Public Open House – January 10, 2022		
Comments	Consultant	Response
A summary of comments by theme from the Open House is below:		
1 Timeframe • What is the timeframe for approval of the project?		1 Timeframe: Zoning and Draft Plan approval should be in hand Fall 2022 Following which conditions of approval will be addressed and a Sit Plan application will be submitted and reviewed by staff. Generally, a Site Plan review can take between 6 8 months. It is expected that servicing work will begin in Spring 2023, followed by house construction in late Summer 2023.
<ul> <li>2 Grading         <ul> <li>O Different grading and elevation to side abutting production (Sumac Court); assumption that grading would be set to be set</li></ul></li></ul>		<ul> <li>Grading: Detailed grading design will be reviewed at the Site Plan stage, but the general rule of thumb is that a development must meet existing grades at the surrounding property line. That can be achieved via max.</li> <li>3:1 slope or with retaining walls.</li> </ul>

Public 1 – January	11, 2022
--------------------	----------

A diagram of the proposed solution for the Sumac Court extension is shown below:

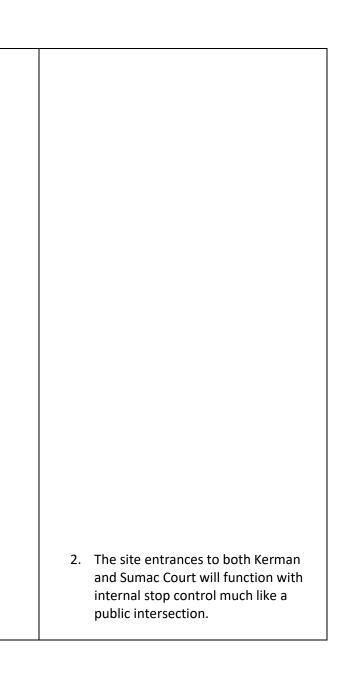
to have an island style median in middle of the proposed Sumac Court extension which would force one directional driving. It would turn the proposed extension into a roundabout style intersection. This has already been done in Grimsby on Sophie Court and Queens Court. An island median in the court extension would add visual separation between the existing development on Sumac Court and the new development. Additionally, it would simplify the intersection/entrances mess and avoid the traffic safety hazards as all vehicles would be forced to drive and turn in one direction. This would prevent vehicles from driving right through and it would also act a traffic calming measure.
